Access Compliance Report

Public Rights-of-Way

(Curb Ramps)

Intersection ID: 8858	Main Street: BROOKSTEAD_DR	Cross Street: NORKETT_DR	Location:	N
ADA ID: 2789B9F4EFBE	Ramp Type: Perp	Initial Pass/Fail: Fail	Overall Compliance: No	Severity Score: 8.75
Codes/Mitigation Info/Possible Solution		Field Measurements/Component Compliance

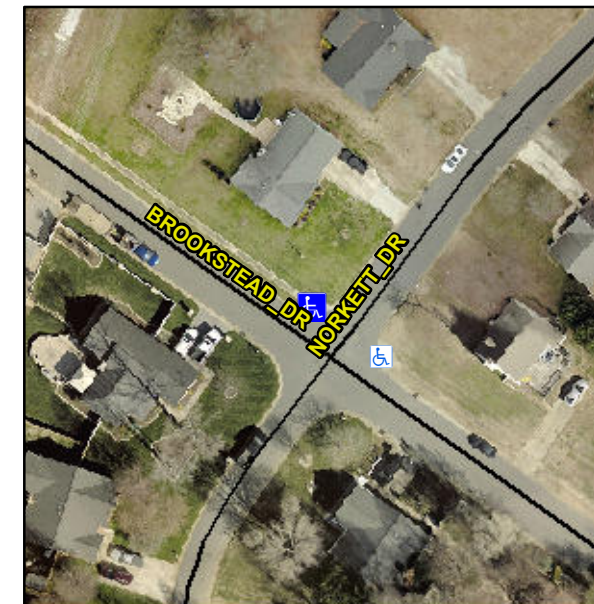
Remove & Replace Entire Ramp.

R304.5.1

Compliance	Description	Data	Compliance	Description	Data
N/A	Ramp Length (in)	61.5	Yes	Ramp Slope (%)	6.4
No	Ramp Width (in)	47.5	Yes	Ramp XSlope (%)	1.7
N/A	Flare Type LT	N/A	N/A	Flare Type RT	N/A
N/A	Flare Slope LT (%)	N/A	N/A	Flare Slope RT (%)	N/A
N/A	Flare Traversable LT?	N/A	N/A	Flare Traversable RT?	N/A
N/A	Landing Length (in)	N/A	N/A	DWS Provided?	N/A
N/A	Landing Width (in)	N/A	N/A	DWS Contrast?	N/A
N/A	Landing Slope (%)	N/A	N/A	DWS Length (in)	N/A
N/A	Landing X Slope (%)	N/A	N/A	DWS Full Width?	N/A
N/A	Landing Curb? (Y/N)	N/A	N/A	DWS Offset (in)	N/A
N/A	Shared Landing?	N/A			
N/A	Gutter Ponding?	N/A	N/A	Gutter Slope (%)	N/A
N/A	Gutter Lip Ht (in)	N/A	N/A	Gutter X Slope (%)	N/A
N/A	Painted X Walk1?	No	N/A	Painted X Walk2?	N/A
	X Walk 1 Direction	To SE		X Walk 2 Direction	N/A
N/A	X Walk 1 Width (in)	N/A	N/A	X Walk 2 Width (in)	N/A
	X Walk 1 Slope (%)	2.6		X Walk 2 Slope (%)	N/A
	X Walk 1 X Slope (%)	0.3		X Walk 2 X Slope (%)	N/A
